Inspection Report for  
**B-52-035**

**STH 56 over FANCY CREEK**  
Mar 08,2018

CORRESPONDENCE WITH DOT FOR BRIDGE REPAIRS

**From:** Jolie Snyder  
**Sent:** Friday, October 26, 2018 10:14 AM  
**To:** Kiekbusch, David - DOT <[david.kiekbusch@dot.wi.gov](mailto:david.kiekbusch@dot.wi.gov)>  
**Cc:** Quirin Klink <[qklink@msa-ps.com](mailto:qklink@msa-ps.com)>; Leah Rhodes <[lrhodes@msa-ps.com](mailto:lrhodes@msa-ps.com)>  
**Subject:** 5730-00-60; STH 56 over Fancy Creek B-52-35 - Railing Question

### OFFSET BLOCK DETAIL

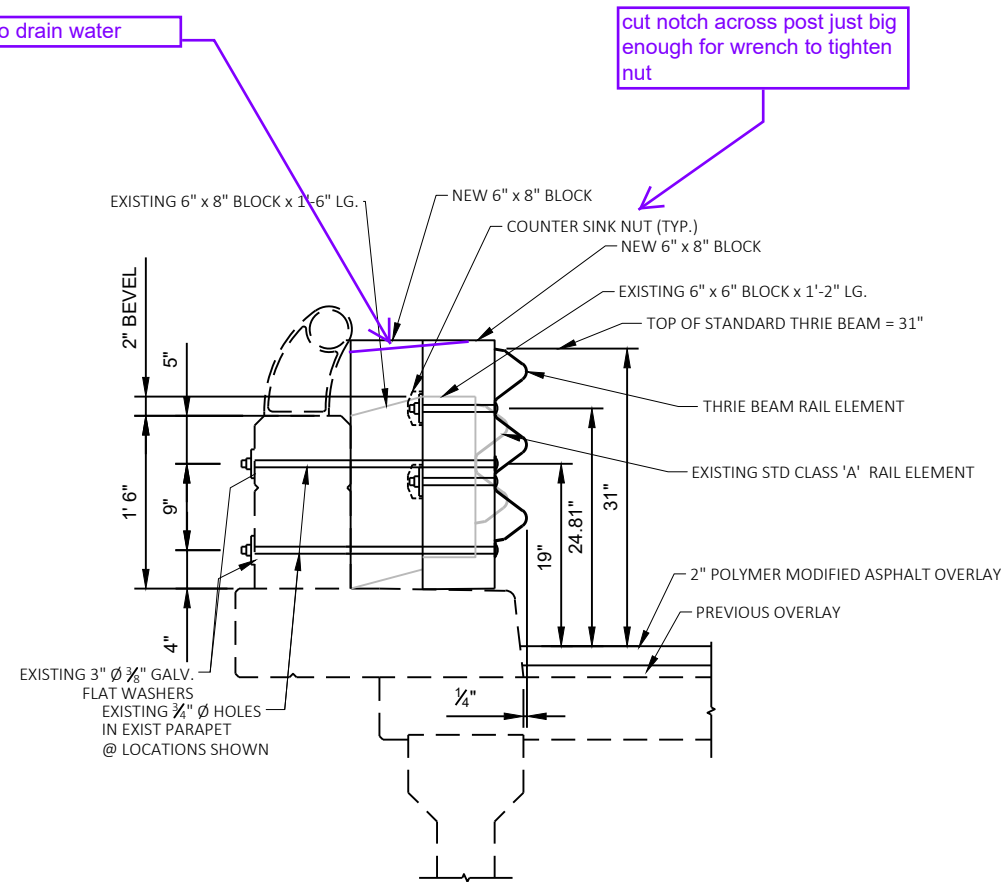
I didn't like the offset in post attached to concrete and one attached to railing. Took a quick look at crash tests and didn't see any test configurations like that.

Actually, I was trying to get you to look at how the bolts look in plan view. I don't know how the Contractor will be able to assemble this detail. If you bolt both posts to concrete you can't get the thrie beam bolt in place. If you bolt the thrie beam to 6" post then you can't get a wrench on the upper long bolt under the thrie beam to tighten it to the concrete.

Recommend using standard size timber blocking so you are not cutting off outer layers of treated material taking into consideration nominal size versus actual size when dimensioning location of thrie beam in relation to curb.

- For Alternate #2 sketch
  - Notes say Thrie Beam is at 31" from pavement, but sketch shows 31" to top of wood block. This gives ≈ 30 1/8" from pavement to top of Thrie Beam. Was this the intent?
  - I assume the new wood blocks will go all the way down to the curb surface. Is this correct?
  - Does the front edge of the Thrie Beam line up with the bottom front edge of the curb or does it project beyond it?
- For structure in general
  - Is the concrete parapet in good condition and did someone visit the bridge to look it over?
  - Is the underside of curb below the parapet in good condition?
  - What is the speed limit at the bridge site?
  - Is the structure or bridge deck on a timeline for replacement? If so, when?
  - There is a lot of cracking and spalling at the curbs. What is being proposed for these regions?

1. The two button head bolts would initially be approximately 6" longer than required, and the wood posts and blocks would be installed loosely on these bolts leaving space between the wood post and offset block to install the bolts through the rail to the offset block.
2. The thrie rail will then be attached and tightened to the offset block.
3. The button head bolts will then be tightened (at the back of the parapet) cinching the whole system together. The extra bolt length then cut off.

Using actual posts sizes (7.5" wide post, 5.5" wide block), the front of the thrie rail would be inset approximately 1.75" from the front of the curb. This is the same as the current configuration on the bridge. (It's hard to tell, but I think the attached photo helps to show the inset thrie rail). We understand this is not desirable under current guidelines, so we are proposing to go to using an 7.5" (8" nominal) wide offset block, so then the front of the thrie rail would be as close as possible to lining up with the curb (sticking out only approx. 0.25" from the front of the bottom of curb).

In response to David's comments on the offset block detail drawing (attached): We will fix the drafting/dimension errors on the detail. The front of the thrie beam will line up very close to the bottom of the curb. (2.5' overhang – 1' parapet footprint – 8" wide post – 6" wide block - 3.25" thrie rail = ¾" from bottom of curb to face of rail).
